Re: Supplement to Petition for Reconsideration -- FMVSS 225, Child Restraint Anchorage Systems
(Docket 98-3390, Notice 2; 64 Fed. Reg. 10786, March 5, 1999)

Ford Motor Company
Supplement to Petition for Reconsideration
FMVSS 225, Child Restraint Anchorage Systems
(Docket 98-3390, Notice 2; 64 Fed. Reg. 10786, March 5, 1999)

CRF Tether Strap Attachment Point

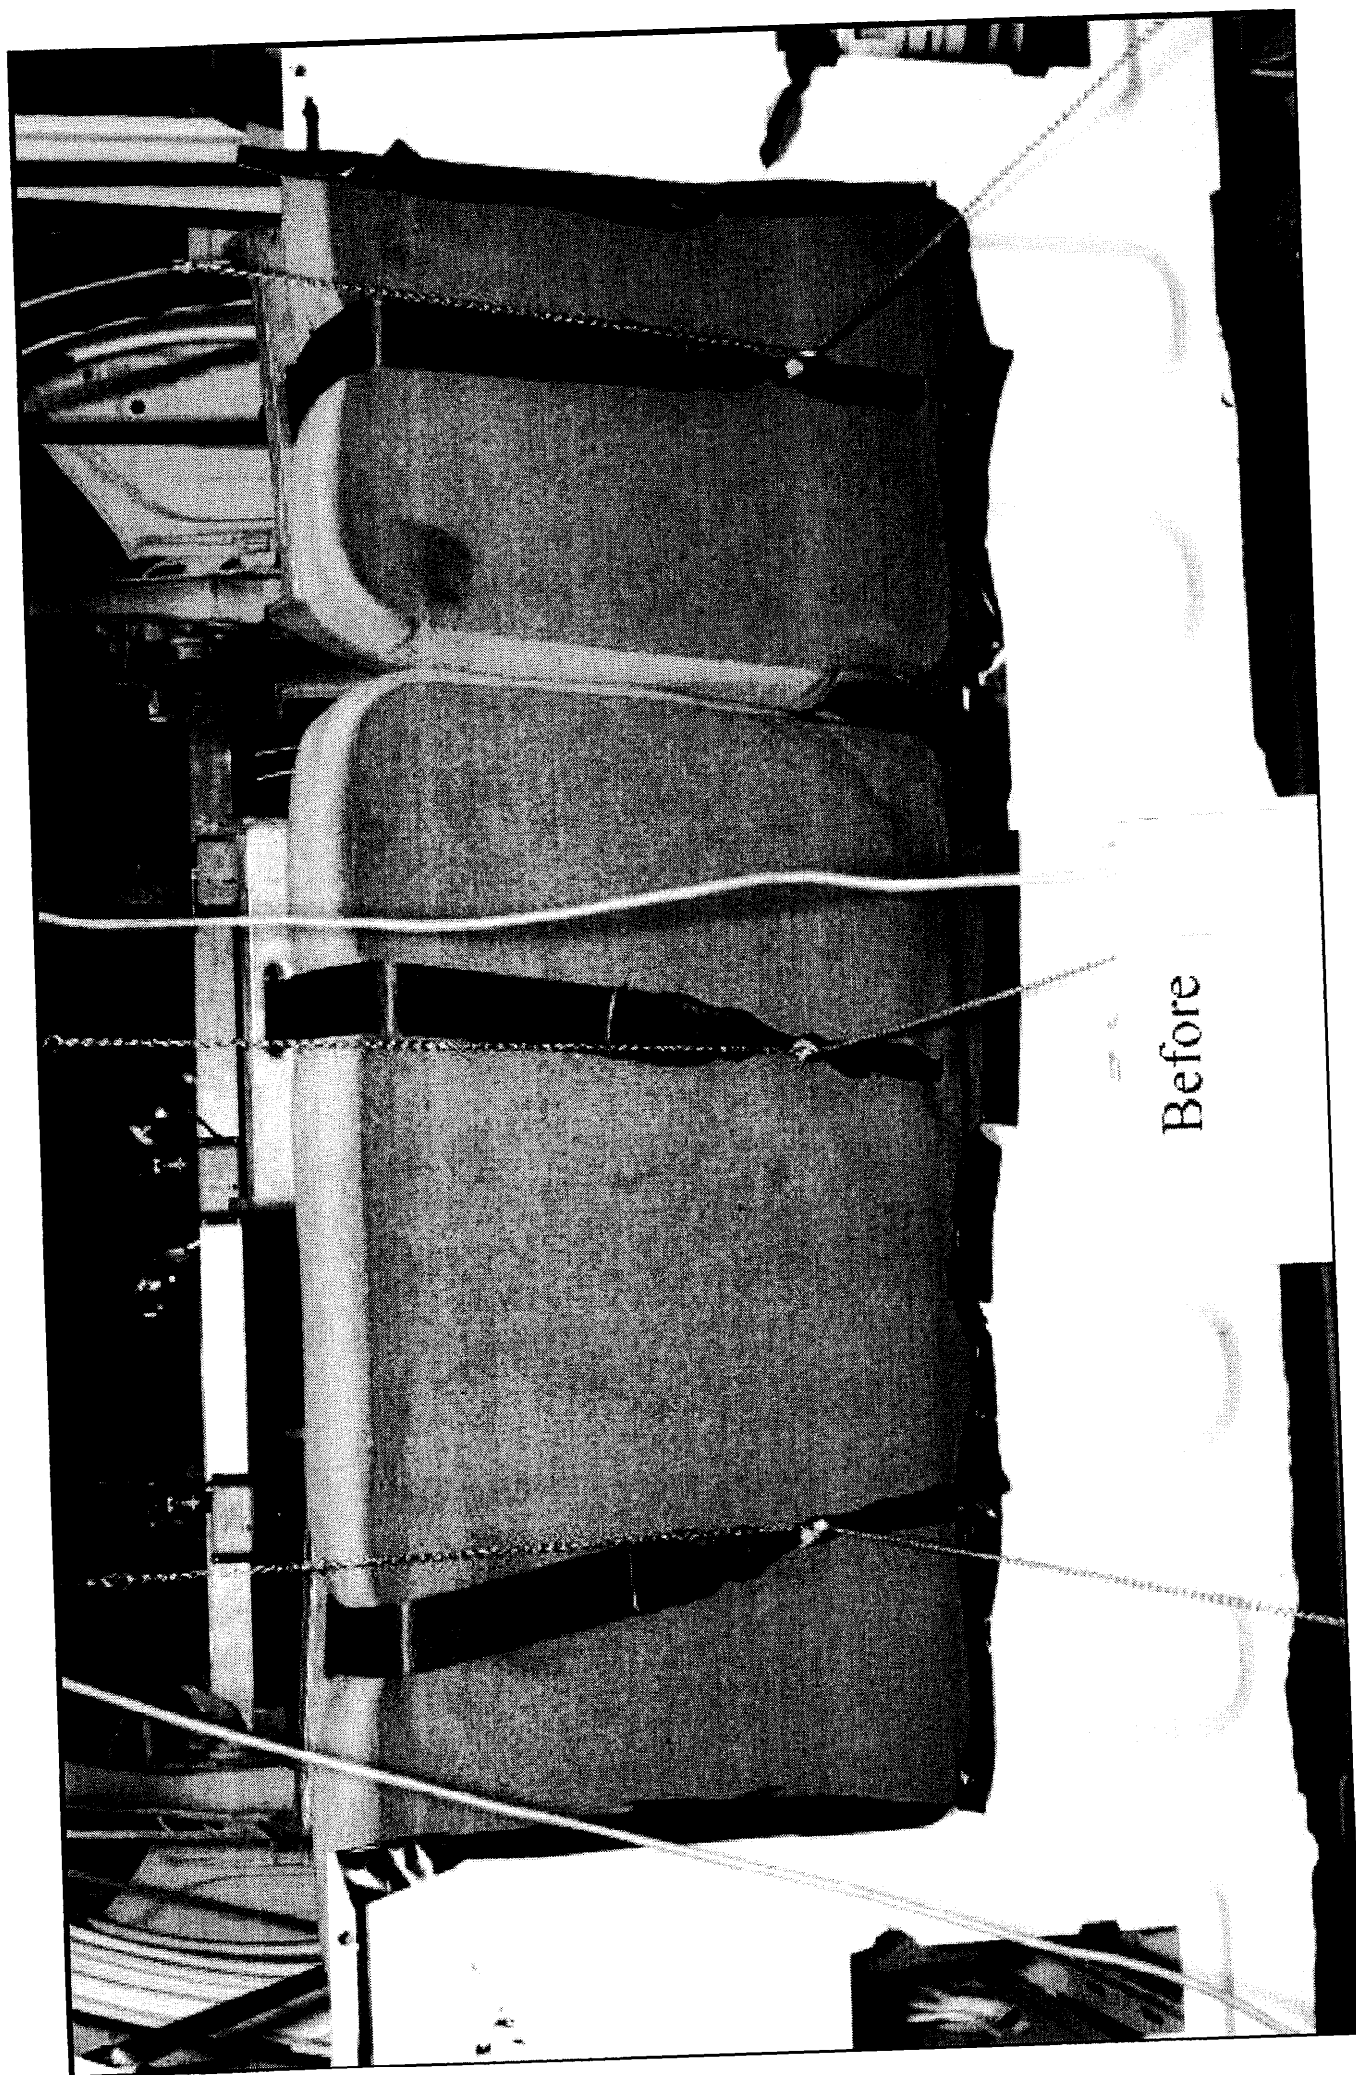
Figure 2 shows a tether strap attachment point on the back of the child restraint fixture (CRF). The back view shows a dimension of 55 mm from the base of the CRF to the tether strap attachment. It appears that this dimension should be 550 mm to be consistent with the location on the figure. But the purpose of this "tether strap attachment" is unclear. This point is not included on the ISO version of the CRF. How is this point used in determining compliance with Standard 225?
